**A66 Northern Trans-Pennine project
TR010062**

**8.1 Change Application –
Application Report**

24 March 2023

Planning Inspectorate Scheme Reference	TR010062
Application Document Reference	8.1
Author:	A66 Northern Trans-Pennine project, Project Team, National Highways

Figure DC-03(b) Indicative layout of proposed change (Before & After)

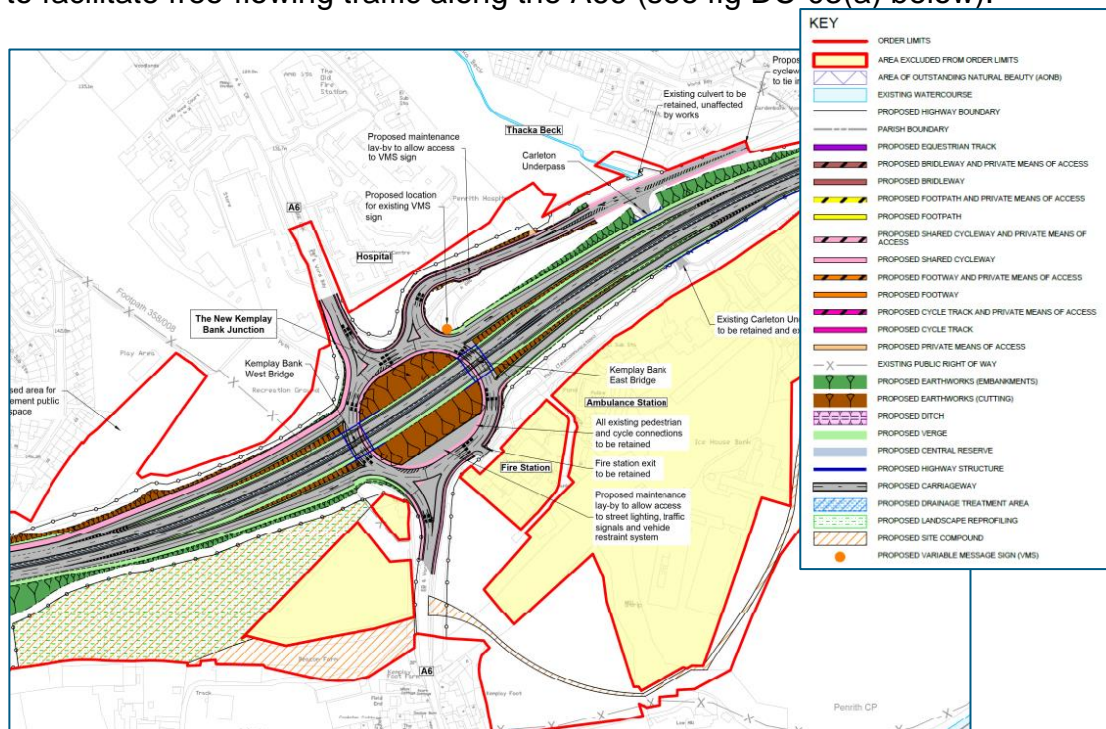
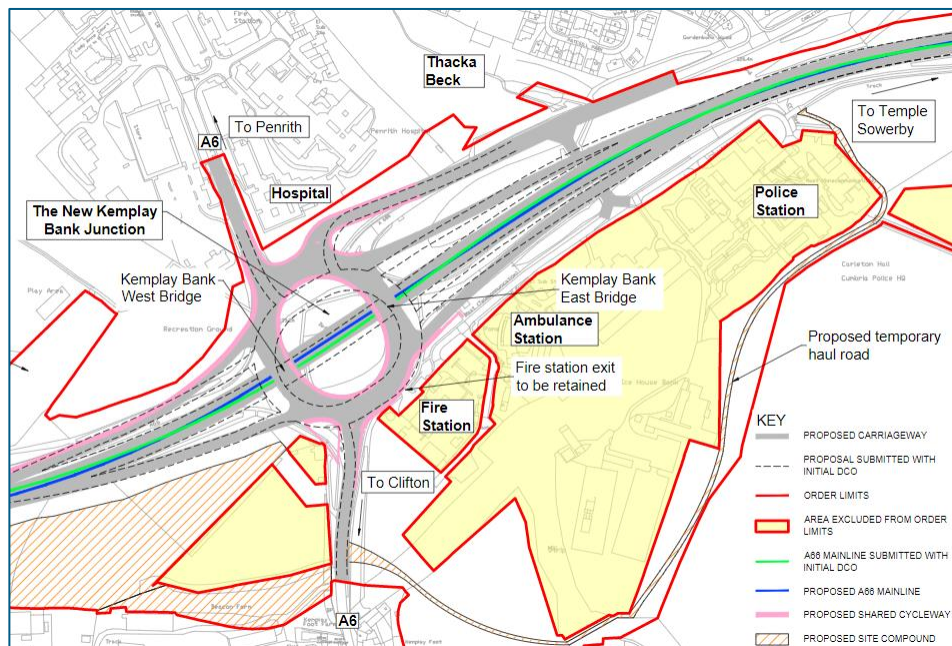
3.3.2. Vehicles slowing down as they approach Kemplay Bank can cause safety issues and create problems for both eastbound/westbound traffic and northbound/southbound traffic as it passes through the roundabout. In our DCO application, an underpass has been introduced at this location to facilitate free-flowing traffic along the A66 (see fig DC-03(a) below):

- 3.3.6. **Alignment/ Design Speed/ Speed Limit:** The change would result in realignment of the circulatory carriageway at Kemplay Bank roundabout (as shown in Figure DC-03(b)).

Figure DC-03(c) Land previously required temporarily that is now required permanently in two locations.

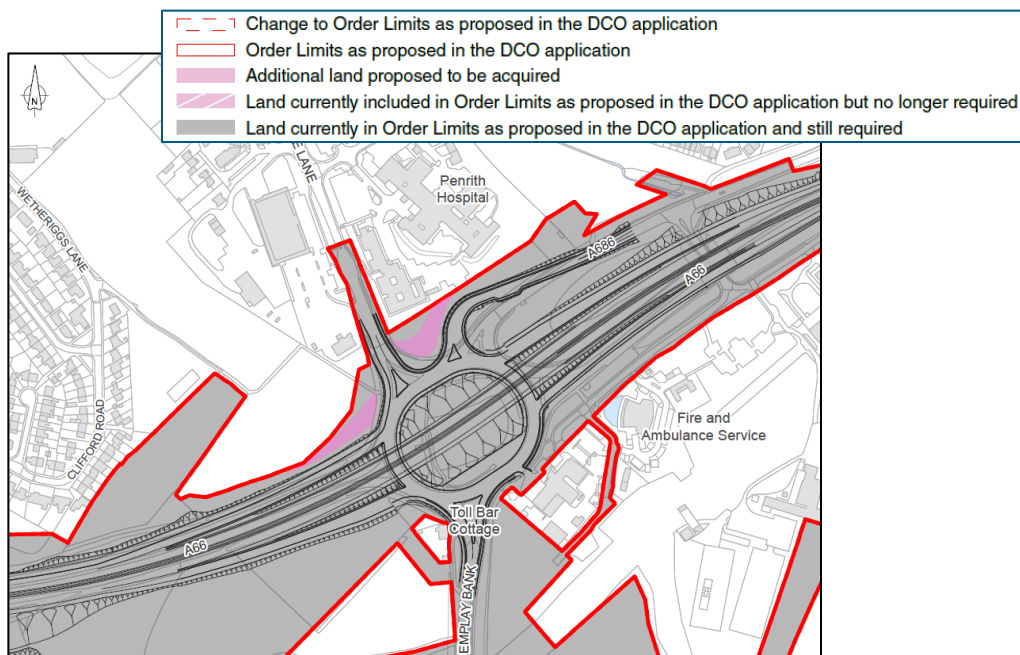
- 3.3.15. The land now required permanently is shown in pink in Figure DC-03(c). Refer to paragraphs below for further details.

Figure DC-03(e) Extract from Works Plans (After)

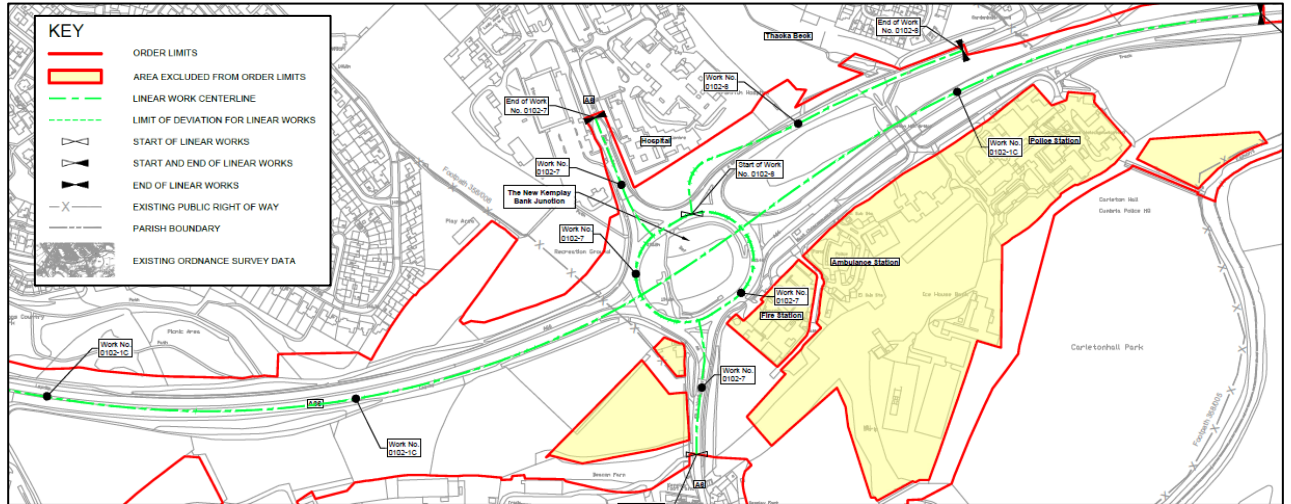
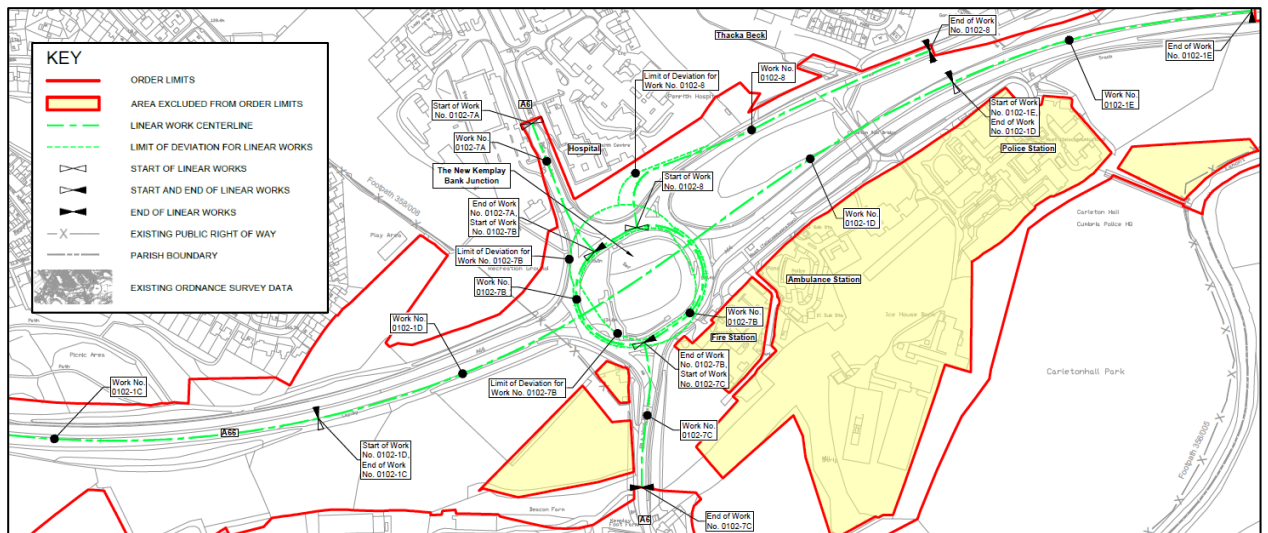
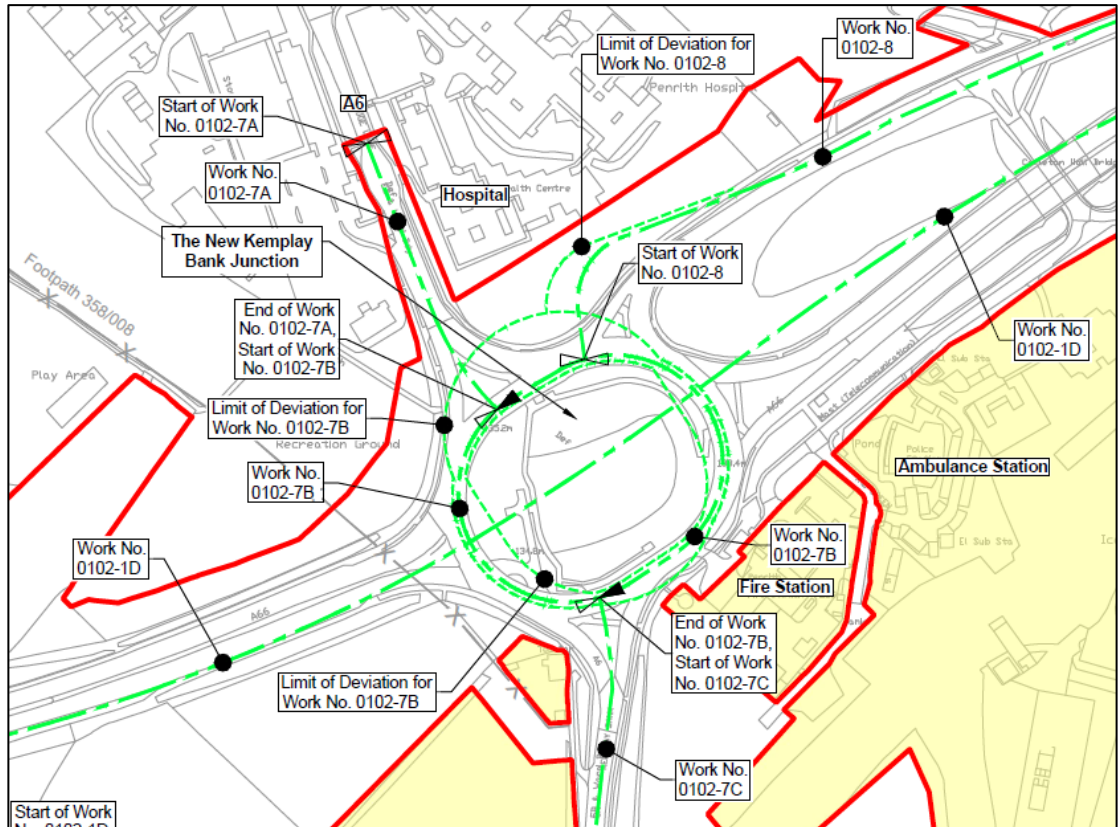
- 3.3.19. The detail in respect to the changes is shown in Table DC-03(a) whilst Figures DC-03(e) & (f) shows the amended work numbers.

Figure DC-05(e) Extract from Rights of Way and Access Plans (After)

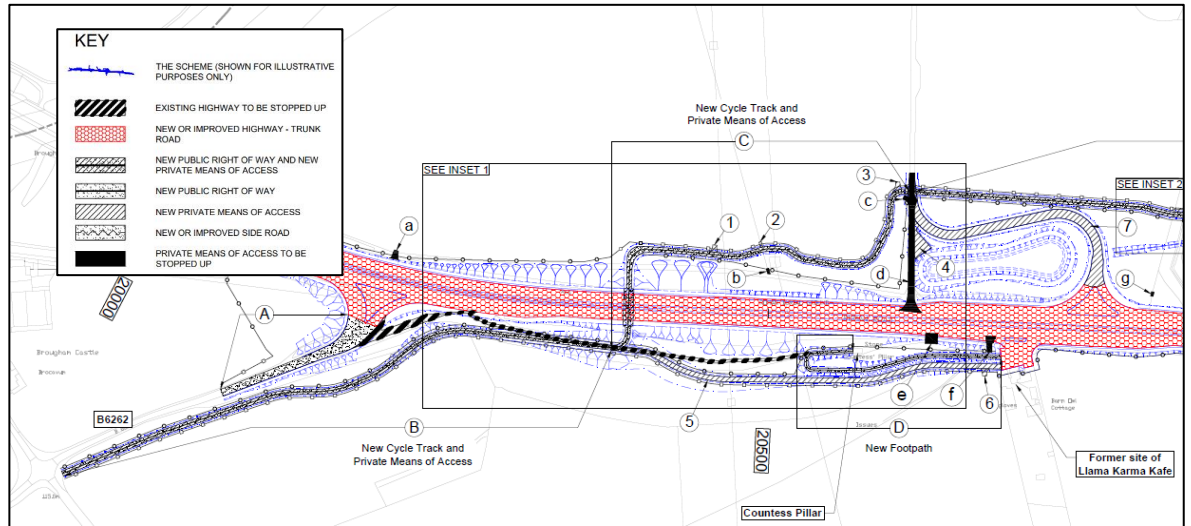
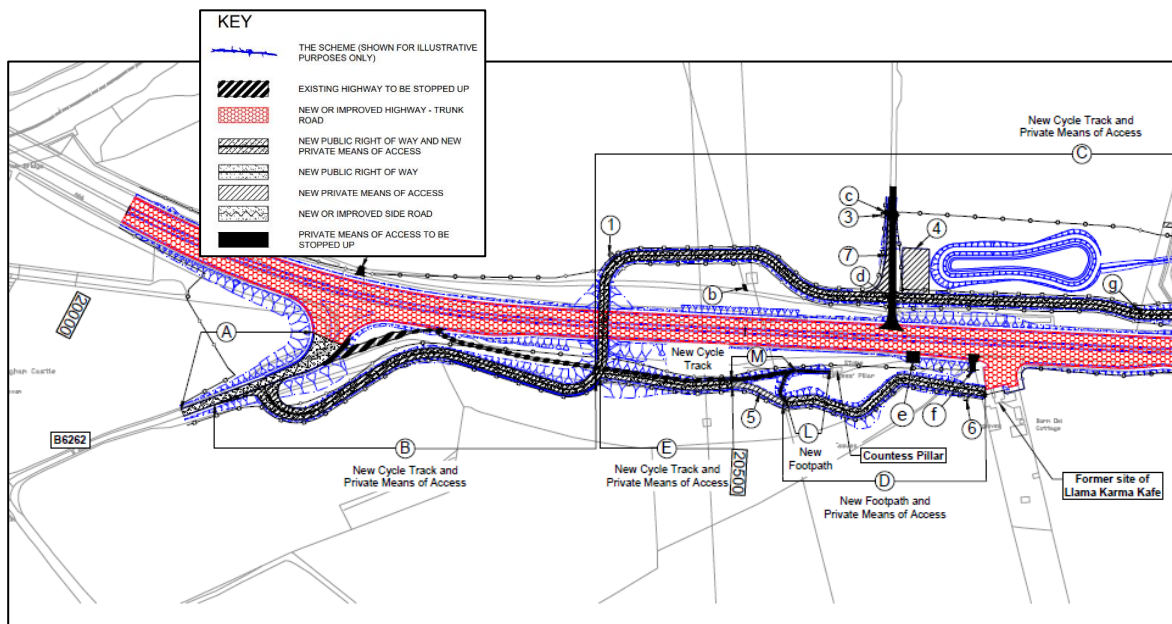
track will be amended to accommodate HGVs as well as walkers and cyclists with the junction created on to the B6262 north-east of its original tie-in point. As part of the proposed change it is intended to retain access to the Countess Pillar for pedestrian movements which was previously removed in the DCO design. These changes are shown in the extracts from the Rights of Way and Access Plans in Figures DC-05(d) and DC-05(e).

Figure DC-05(g) Extract from Works Plans (Before)

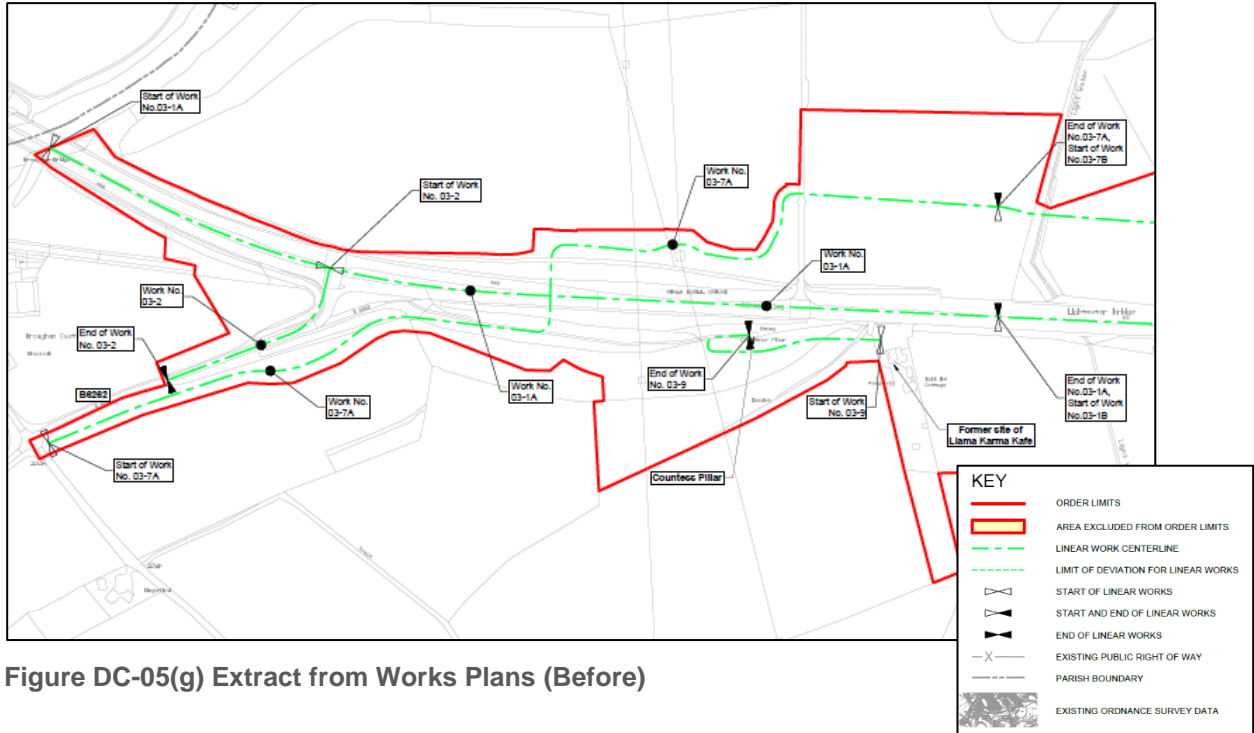
- 3.5.23. The detail in respect of the LoDs changes is shown in Table DC-05(a) whilst Figure DC-05(h) shows the amended work numbers.

Figure DC-06(c) Extract from Works Plans (Before)

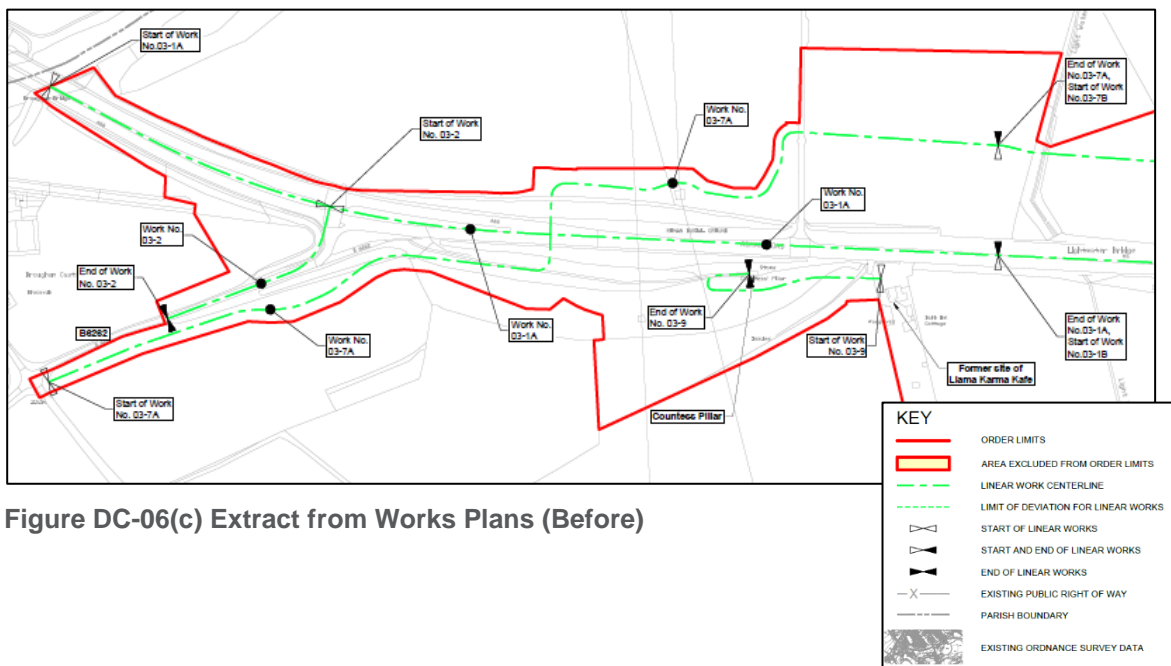
- 3.6.6. **Alignment/ Design Speed/ Speed Limit:** This change could result in an increased vertical level over the Shell pipeline over a distance of up to 400m (see Works No 03-1AA contained within Fig DC-06(d)). Increasing this level will require amendments to the vertical alignment of the A66 (associated with new Work No. 03-1AA) to transition back to the original levels. The horizontal alignment of the A66 will remain unchanged.

Figure DC-08(e) Extract from Mainline Profile Ch 22410m to Ch23810m (After)

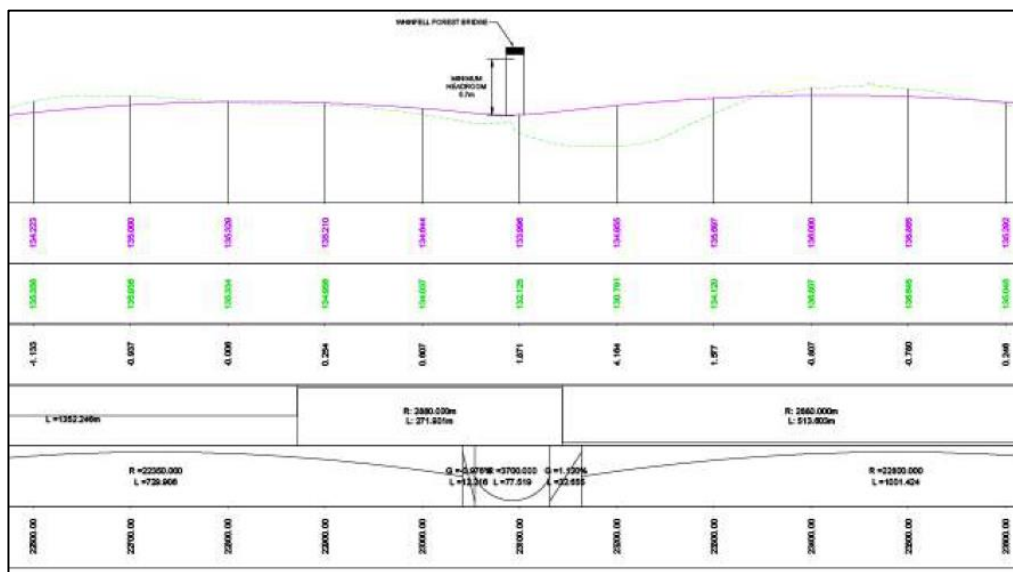
- 3.8.7. **Alignment/ Design Speed/ Speed Limit:** This change will result in a lowering of the vertical alignment of the mainline A66 through the new junction at Center Parcs, to more closely match the existing road level as far as possible whilst complying with dual carriageway design standards (see Figure DC-08(e)). The vertical alignment of the proposed connector road associated with the compact grade separated junction (Work No. 03-4A) will be amended and raised to meet a new bridge structure

Figure DC-08(f) Extract from General Arrangement Drawing (After)

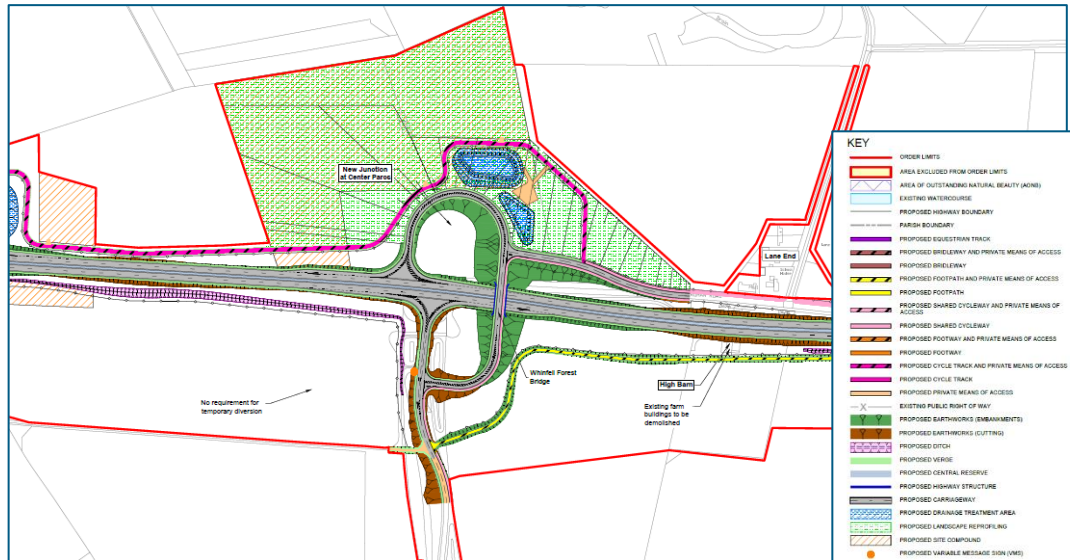
- 3.8.10. **Public Rights of Way/Access Tracks:** Proposed changes to the shared track (shown as per the DCO design in Figure DC-08(a)) to the south-east of the junction are included as part of DC-05 and are not represented here.
